ADDENDUM NO. 2

**Federal Aid Project No. NHP-002S(539)
Bridge Replacement Br. No. C-07-001 (Single Leaf Bascule) Bridge Street
over the Mitchell River (ABP)**

CHATHAM
Federal Aid Project No. NHP-002S(539)
Bridge Replacement Br. No. C-07-001 (Single Leaf Bascule)
Bridge Street over the Mitchell River (ABP)

RESPONSE TO BIDDER QUESTION

ABUTMENT SECTIONS

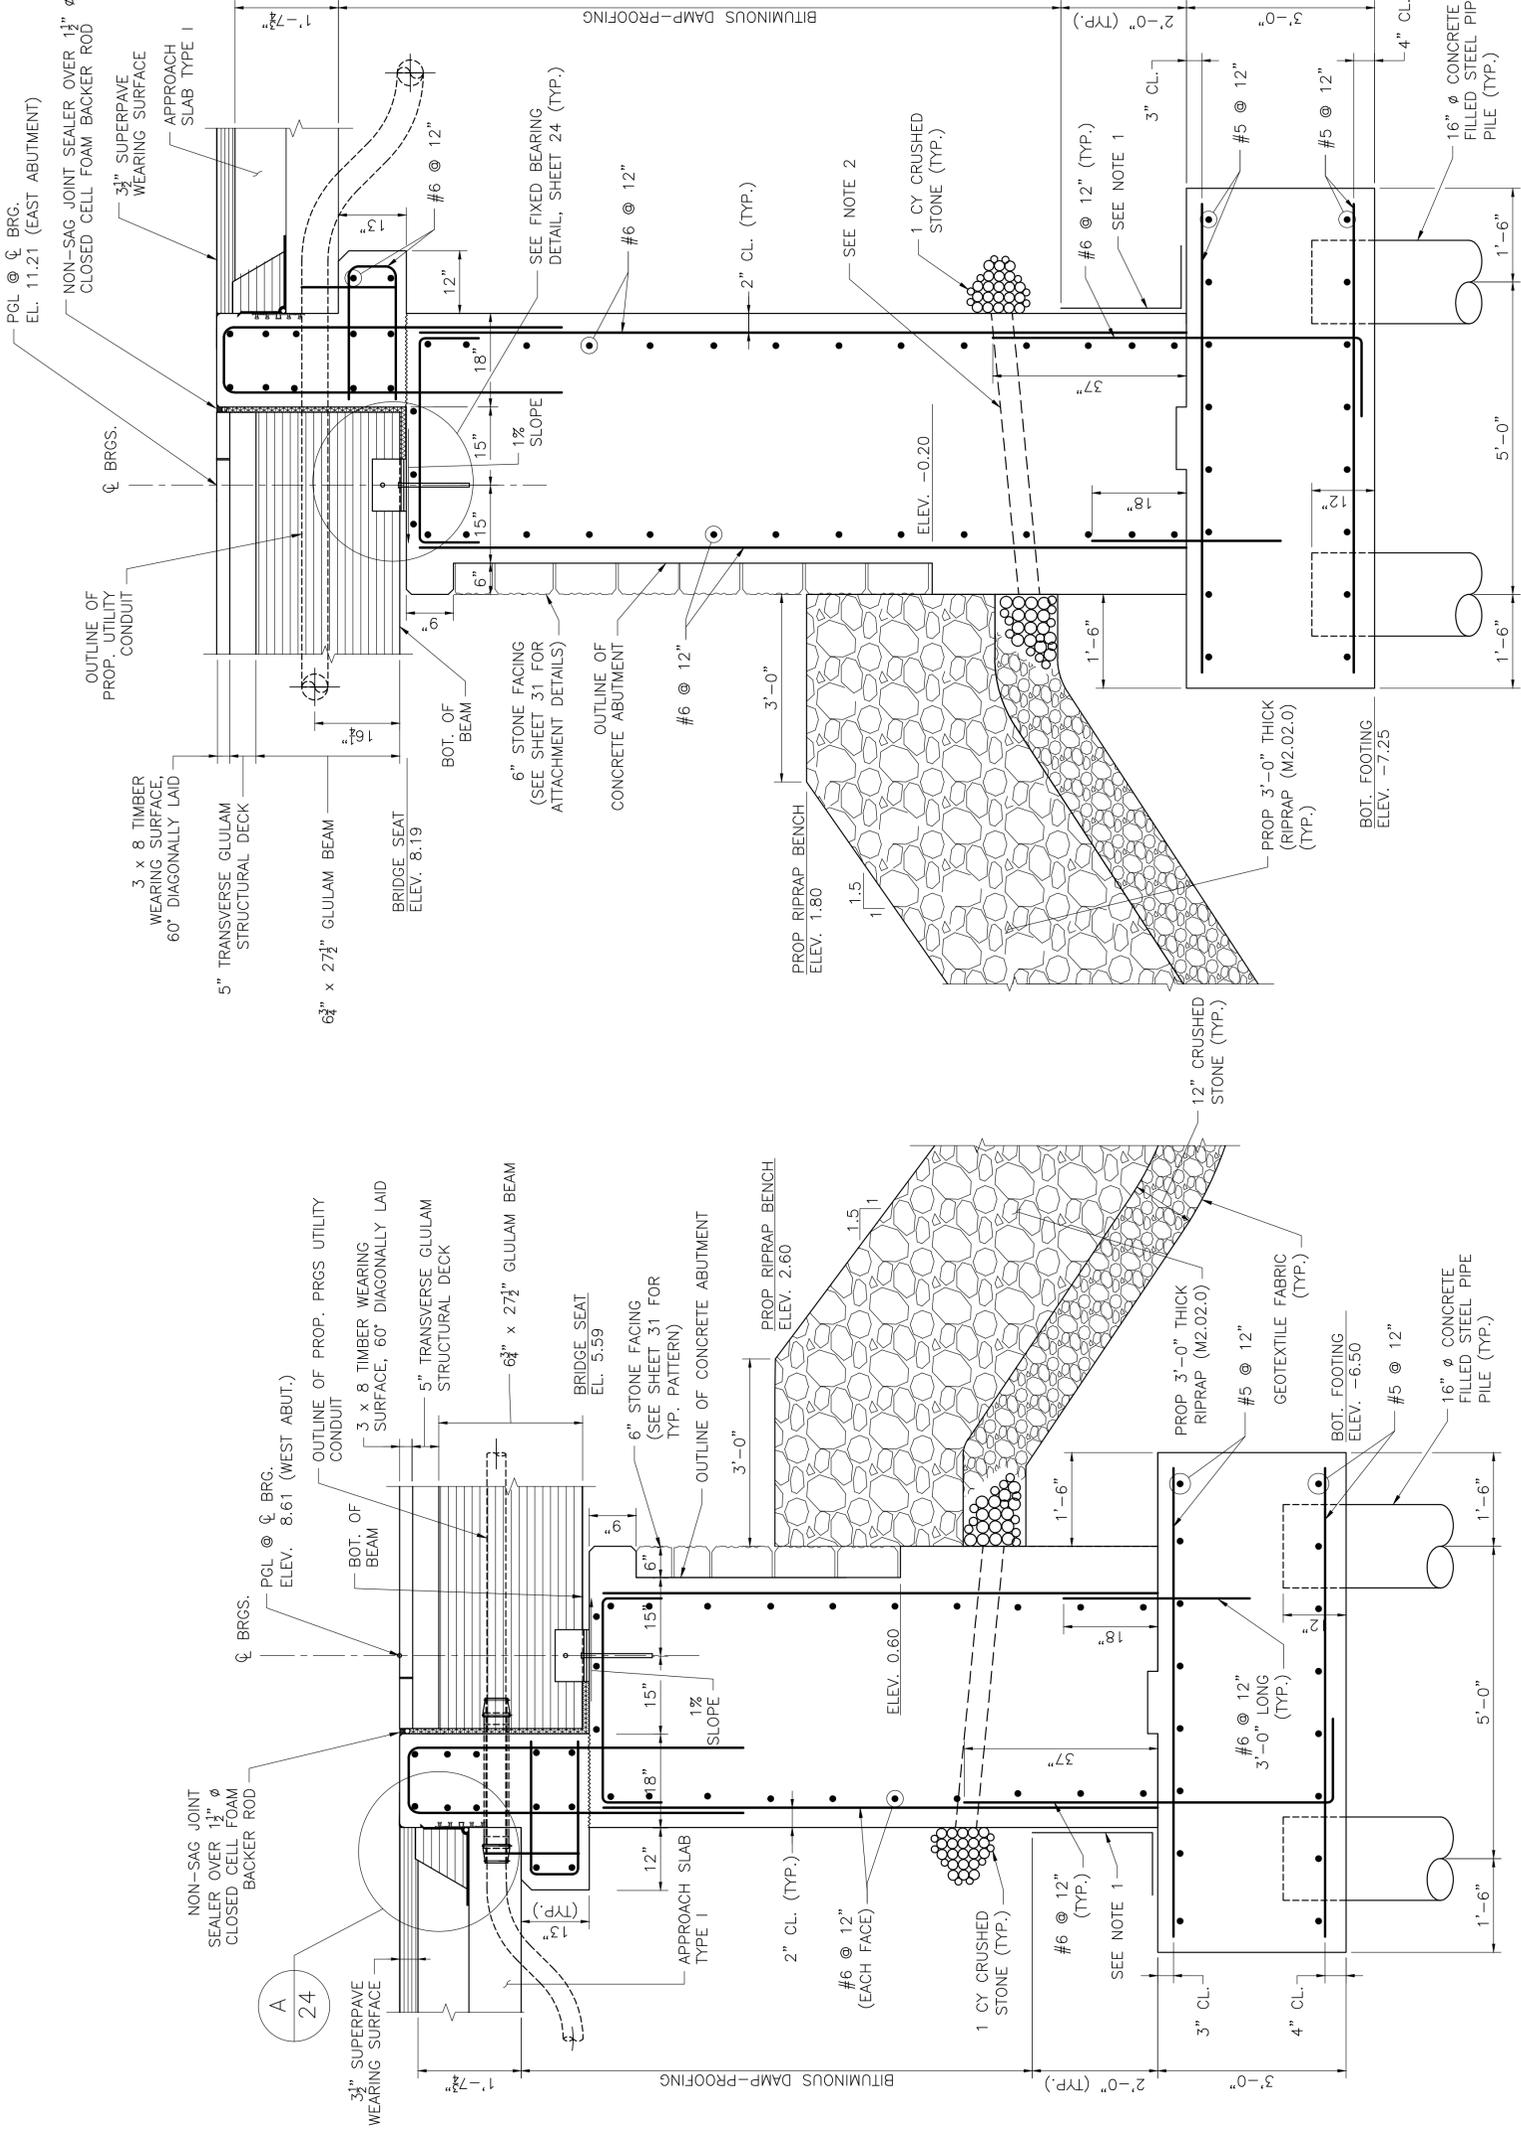
FEB. 28, 2014	REVISED NOTE 3 - ADDENDUM 2
OCT. 26, 2013	ISSUED FOR CONSTRUCTION
DATE	DESCRIPTION
USE ONLY PRINTS OF LATEST DATE

BASCULE PIER AND REST PIER PLANS
1 OF 3

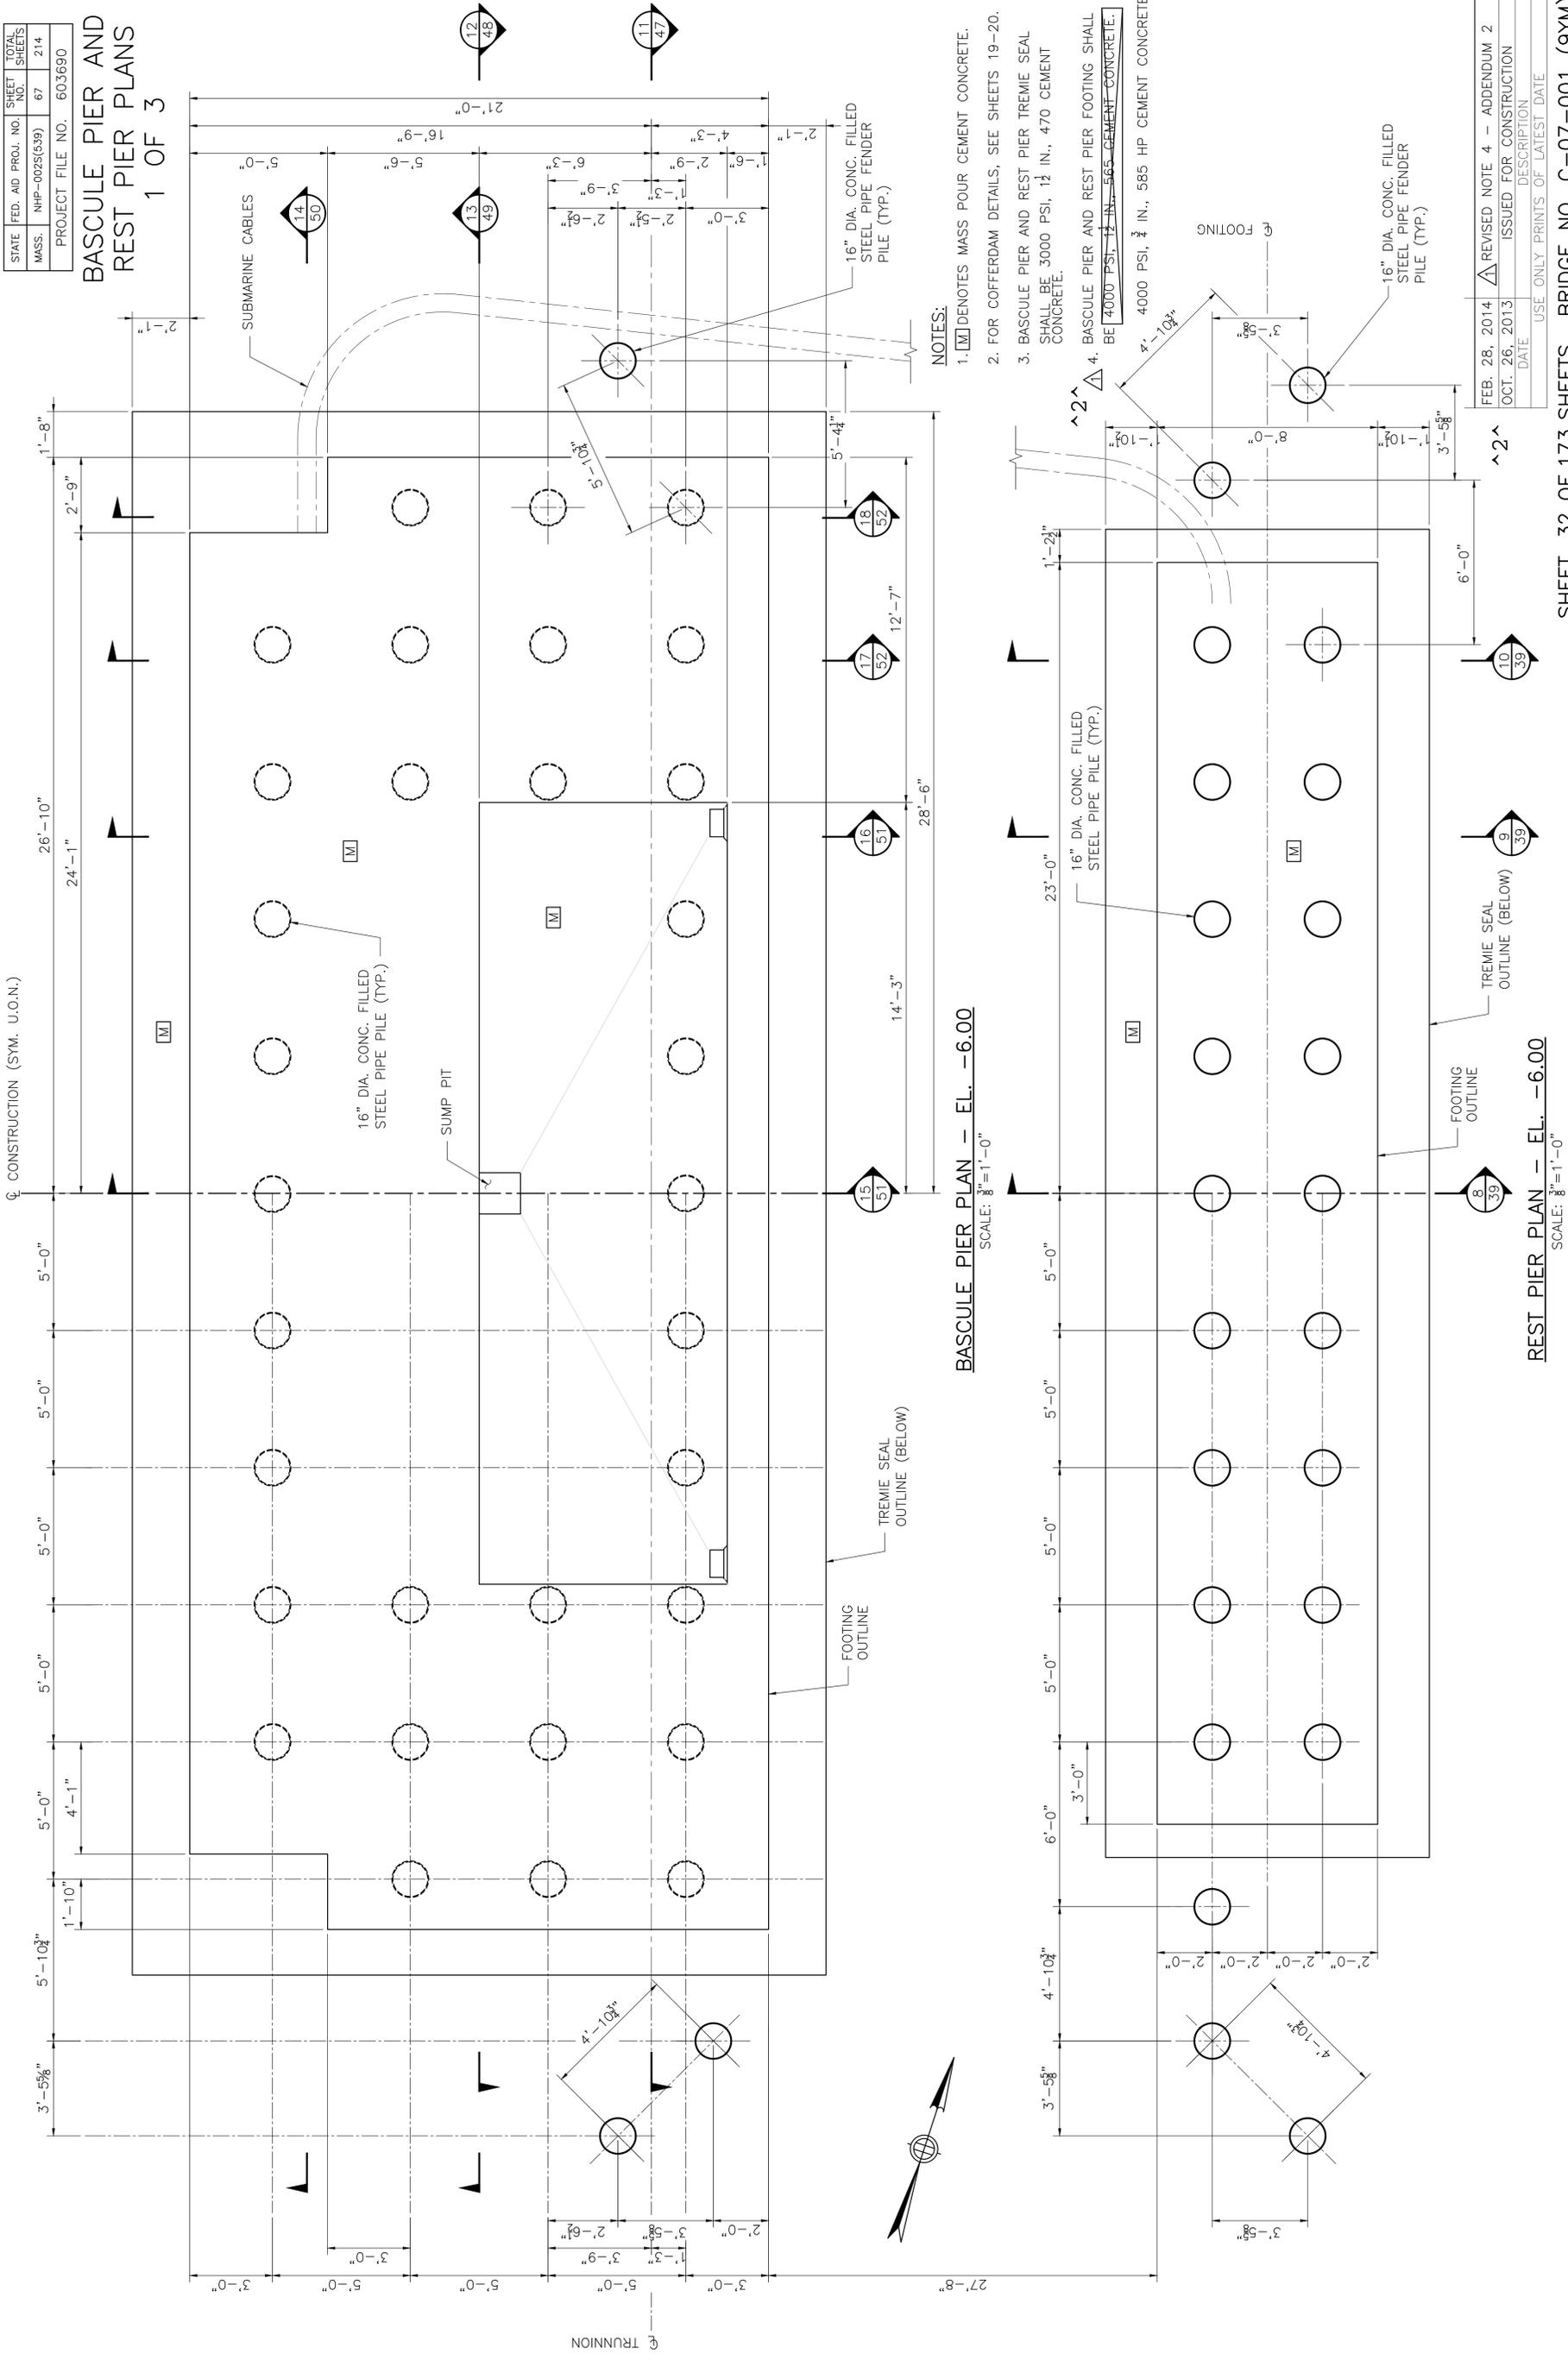
FEB. 28, 2014	REVISED NOTE 4 - ADDENDUM 2
OCT. 26, 2013	ISSUED FOR CONSTRUCTION
DATE	DESCRIPTION
USE ONLY PRINTS OF LATEST DATE

BASCULE PIER AND REST PIER PLANS
2 OF 3

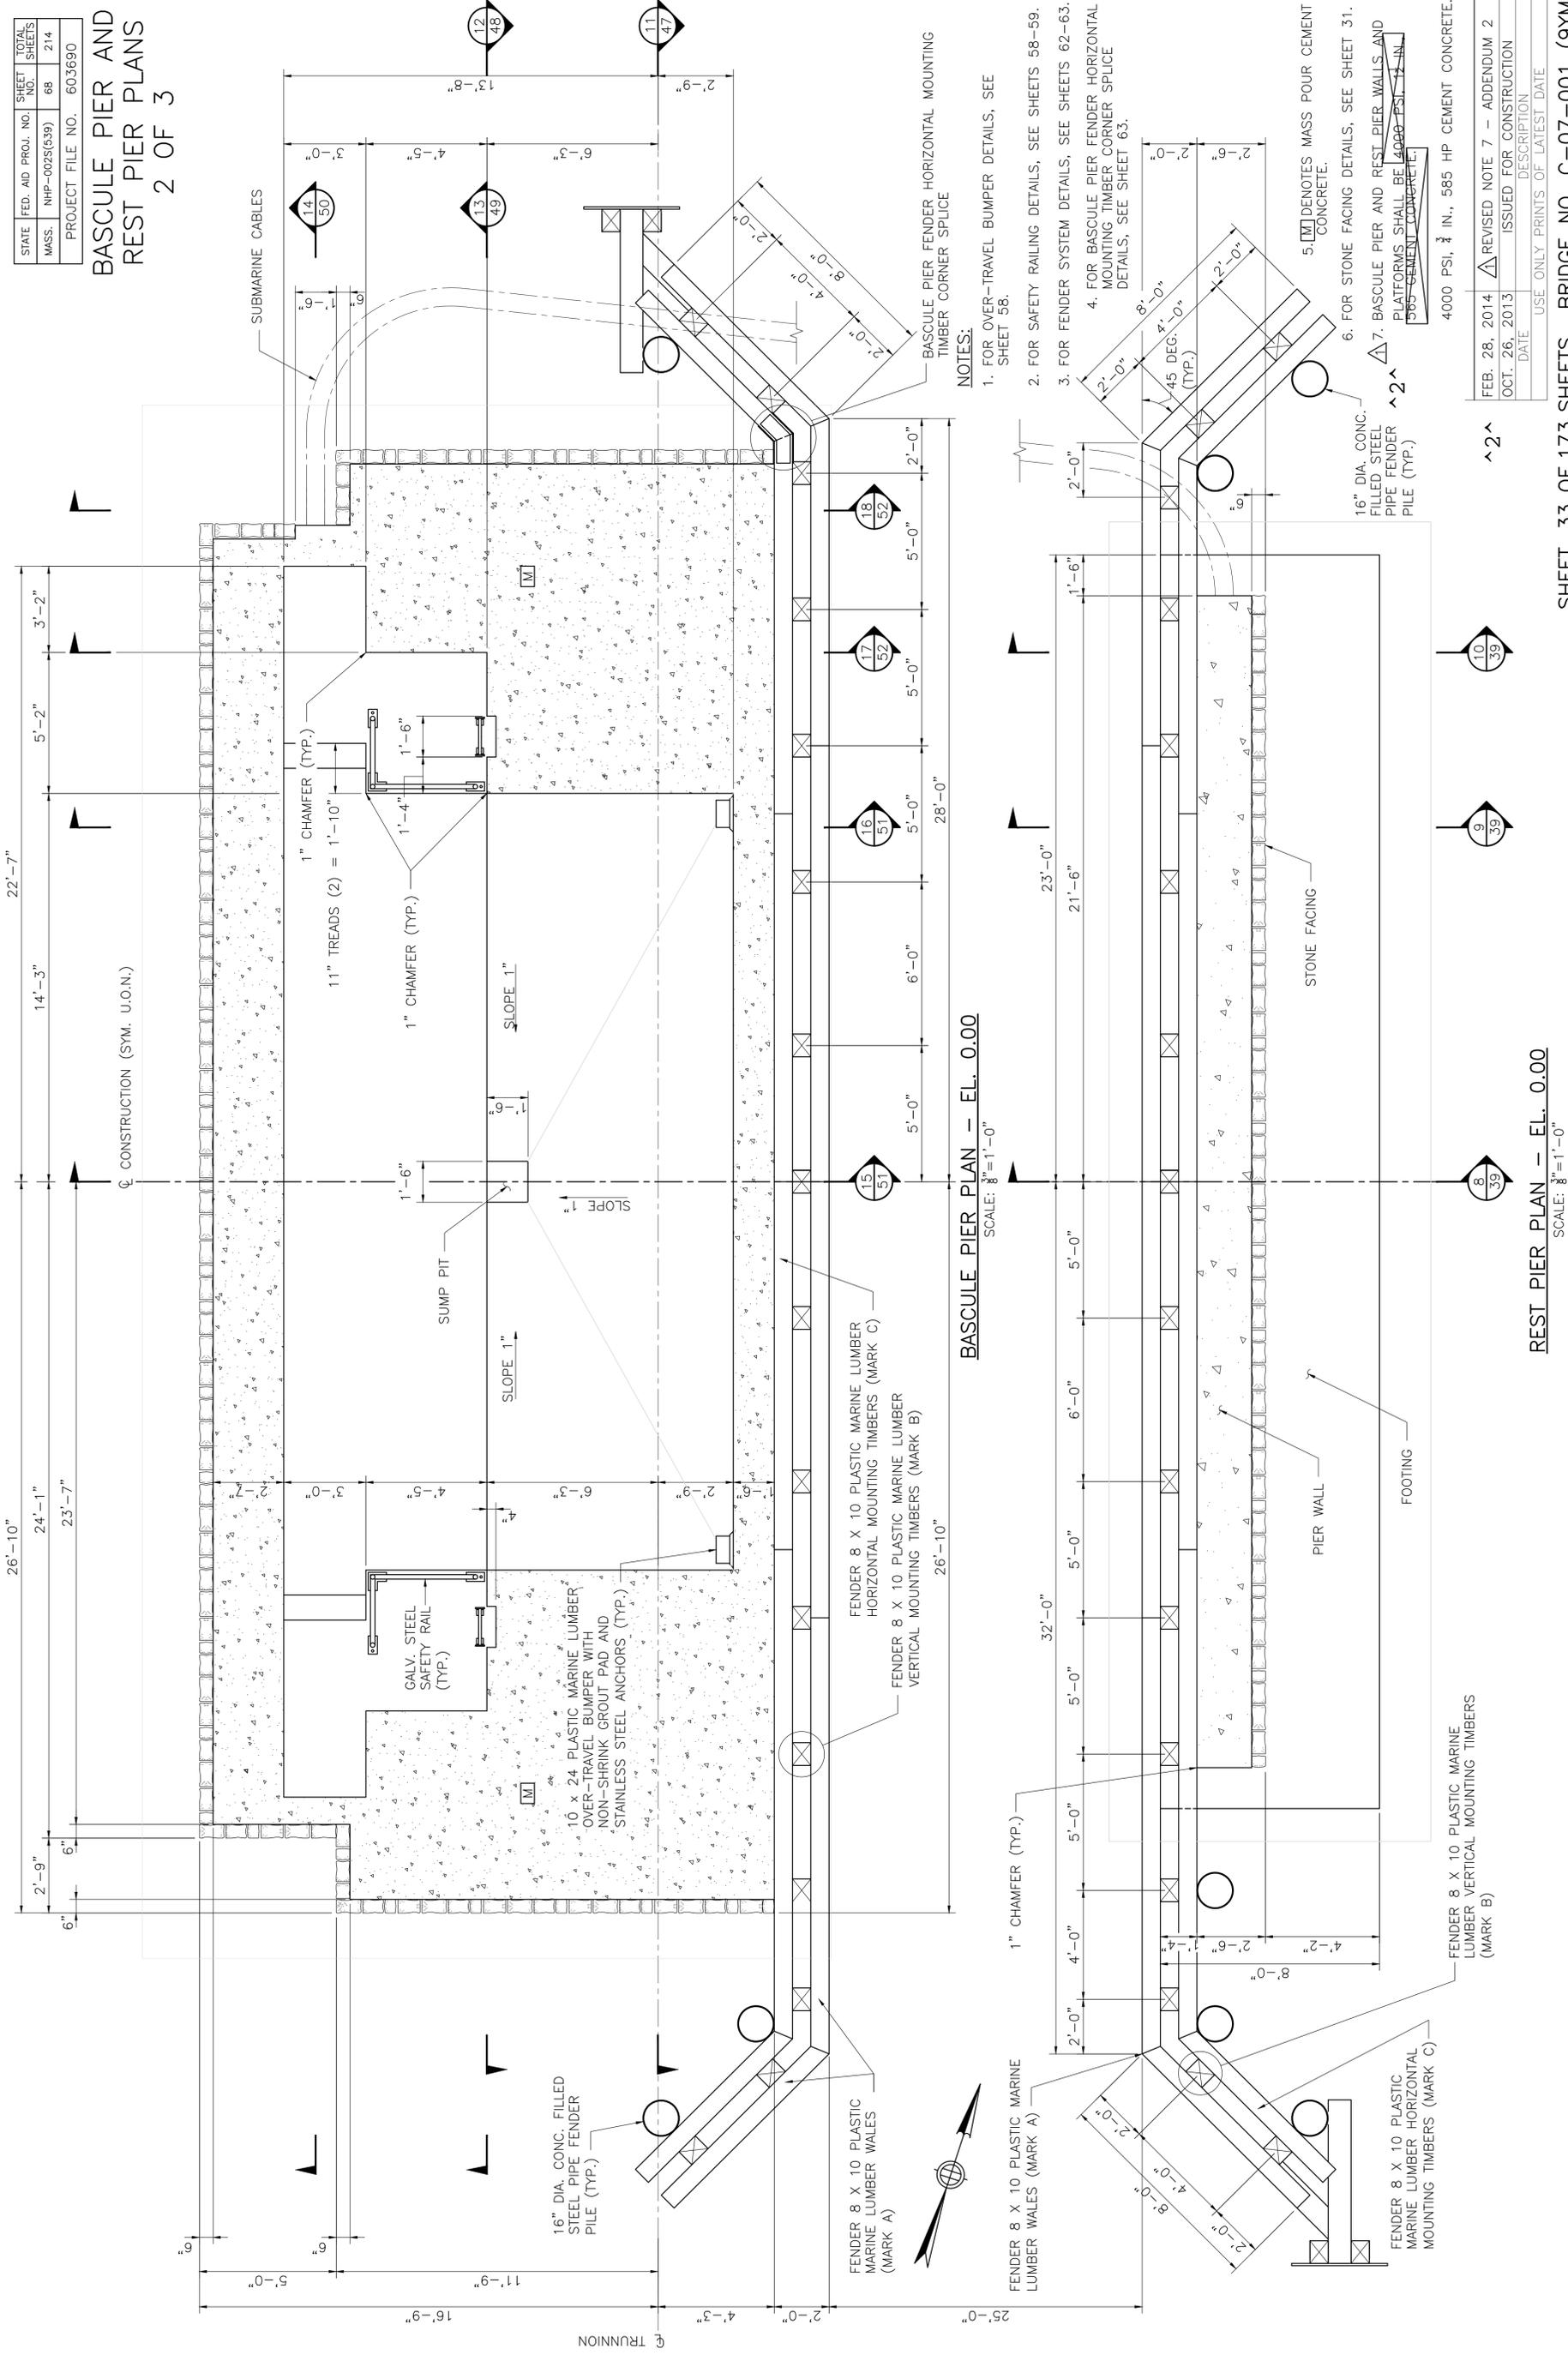
FEB. 28, 2014	REVISED NOTE 7 - ADDENDUM 2
OCT. 26, 2013	ISSUED FOR CONSTRUCTION
DATE	DESCRIPTION
USE ONLY PRINTS OF LATEST DATE
